Brisbane Central Business District Bicycle User Group

This letter concerns TMR policy on Bicycle Awareness Zones (BAZ) in both a specific implementation in Moggill Road, Kenmore, and as a matter of public policy advice.

Moggill Road BAZ

Figure 2
Mean Preference Score for 16 Route Types According to Cyclist Segment (A) and Gender (B)

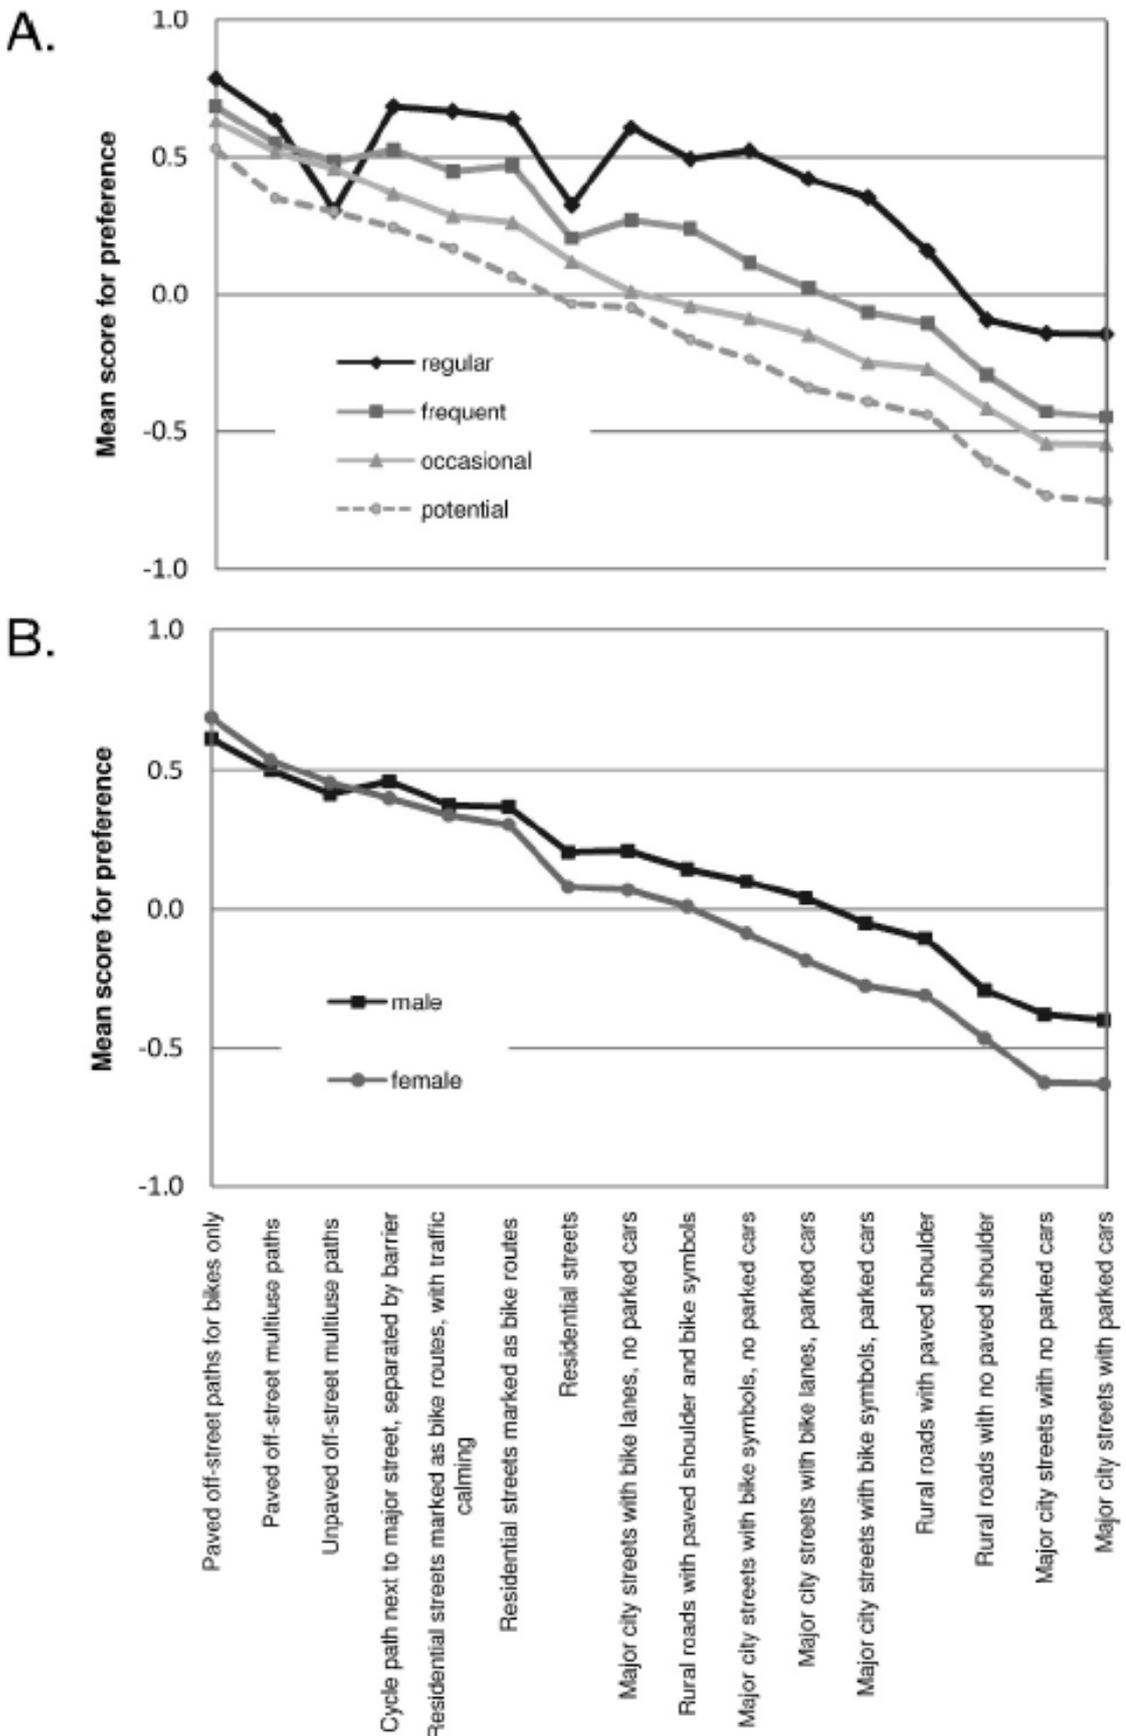
Study subjects were shown 3 photos of each of 16 route types, including sharrows. Here they are called “major city streets with bike symbols”, with or without parked cars. Figure 2 makes clear that sharrows on streets with or without parked cars received negative ratings from women, potential and occasional cyclists.

though the results are not shown. Sharrows on streets with parked cars received negative ratings from all groups except regular cyclists. The upshot is that sharrows do not encourage cycling, and therefore have no value as an addition to a “bike network”.

Bike lanes, particularly without parked cars were better than sharrows, but our conclusion, based on the results of the preferences study and the injury study, is that the only route type that both is safe and encourages cycling on collectors or arterials is cycle tracks (physically separated bike lanes).
